Technical Service Bulletin

93: High-Voltage fault, gearbox fault or MIL on in the instrument cluster DTC(s) P0A4000, P0A2E00 or P0A2B00

93 24 00 2066596/2 July 31, 2024. Supersedes Technical Service Bulletin Group 93 number 22-69 dated March 25, 2022 for reasons listed below.

Model(s)	Year	VIN Range	Vehicle-Specific Equipment
A7 e quattro	2021 – 2022	All	Not Applicable

Figure 1. Connector locations.

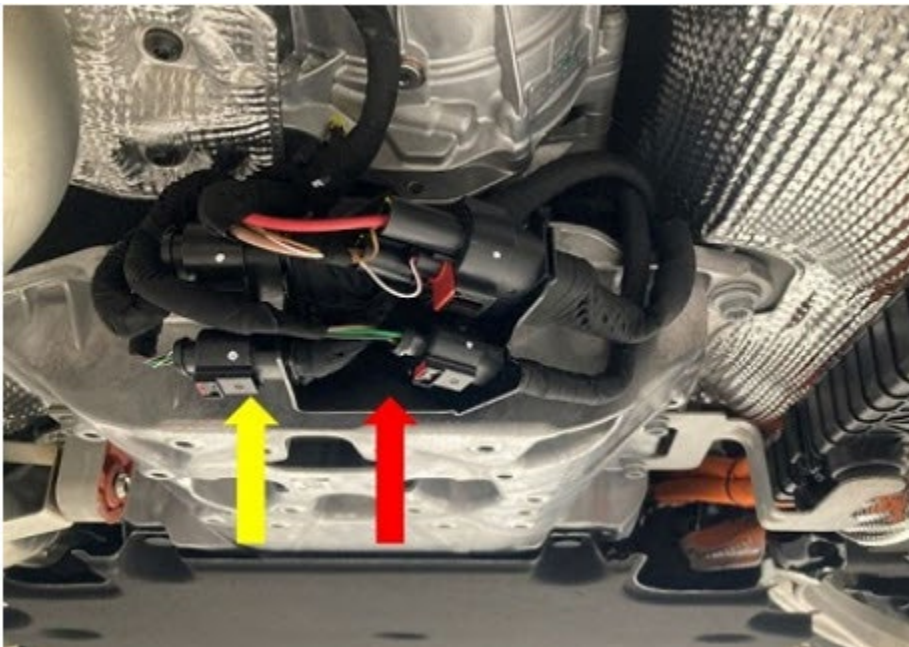
Contact abrasion in connector T6bm / T6bmx.

1. Replace the connector housing bracket installed in the vehicle with the new bracket 8W0.971.502.AL (Figure 1 red arrow).
2. Replace the connector at the coupling point T6bm/T6bmx with 3B0.973.813 and 4H0.973.713.G (Figure 1 yellow arrow).
3. Replace all the pins in the new connector and mating connector with gold-plated pins using the wiring harness set VAS 1978B/C.
4. For modified connector 3B0.973.813, use single wires 000.979.041.EA and for connector 4H0.973.713.G use single wires 000.979.025.EA.
